**Verification and certification report form for  
GS project activities  
(Version 03.0)**

BASIC INFORMATION	
<b>Title and GS reference number of the project activity</b>	Title: Sustainable Market Development of Improved cooking in rural Nepal by Practical Action GS reference no.: GS 10788
<b>Scale of the project activity</b>	<input type="checkbox"/> Large-scale <input checked="" type="checkbox"/> Small-scale <input type="checkbox"/> Micro-scale
<b>Version number of the verification and certification report</b>	4
<b>Completion date of the verification and certification report</b>	15/09/2023
<b>Monitoring period number and duration of this monitoring period</b>	3 <sup>rd</sup> monitoring period. Duration: 22/06/2021 to 21/06/2022 (including both days)
<b>Version number of the monitoring report to which this report applies</b>	1.4 dated 01/09/2023
<b>Crediting period of the project activity corresponding to this monitoring period</b>	02/09/2019 to 01/09/2024
<b>Project participants</b>	Value Network Ventures Advisory Services Pte. Ltd.

**CL ID** 03 **Section no.** ER sheet **Date:** 16/05/2023

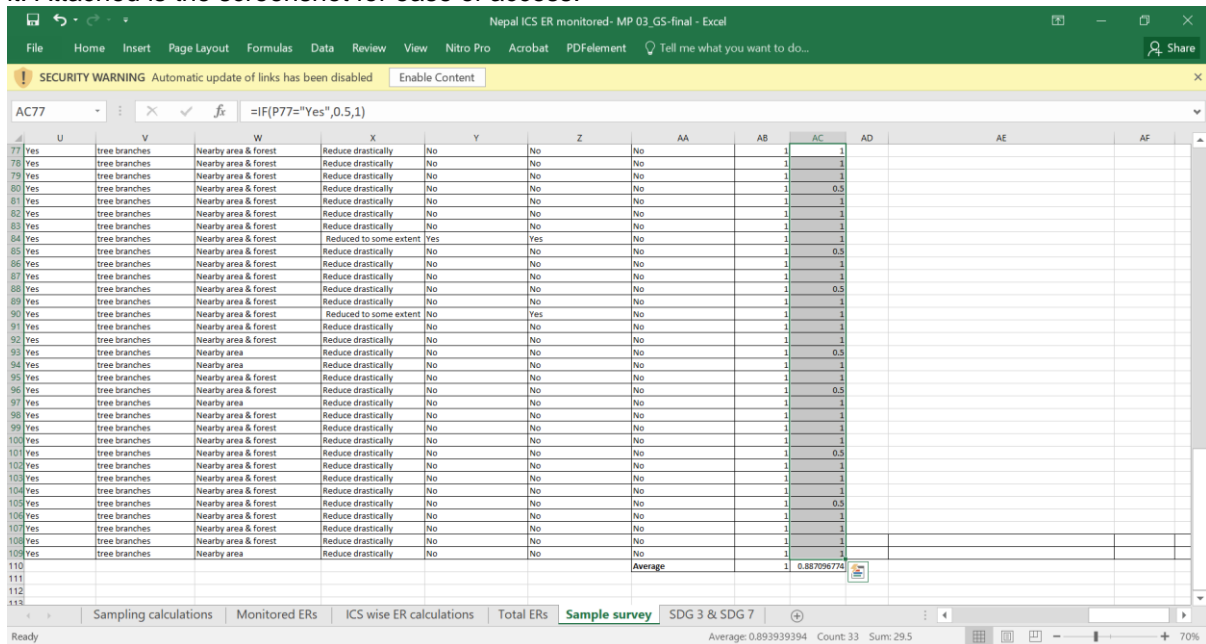
Based on the review of the ER spreadsheet, sheet "Sample survey" column AC, VVB has observed that for the calculation of the parameter uy, the no of HH included in the calculation for average value is 33, 32, and 31 for the stoves HPNJE-01ND, HPN-01FD, and Greenway Jumbo respectively from the total sample size of 33 for each stove. PP is requested to clarify the difference in the number of HH included in the calculation for the 3 different stoves.

PP would like to request that please check the count in the ER sheet, tab-sample survey and not the sum of it. Attached is the screenshot for ease of access.
